TITLE:
Incorrect fuel level indication

REF NO: TJ 25612	ISSUING DEPARTMENT: Technical Service	CAR MARKET: United States and Canada
PARTNER: 3 US 7510 Volvo Cars North America		ISSUE DATE: YEAR MONTH DAY 2013 08 14
FUNC GROUP: 2341	FUNC DESC: Fuel Tank	Page 1 of 3

TJ Instruction	
		TJ No 25612	
		Date August-13 Issue 01	
Title	Incorrect fuel level indication

Photo 1. Alignment mark

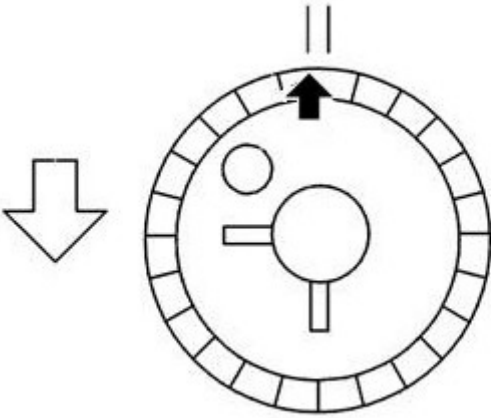
The left level sensor may not achieve full travel.

In case of faulty level indication despite being inside alignment marks please loosen lock ring and rotate left level sensor to line up with left alignment mark as shown in attachment.
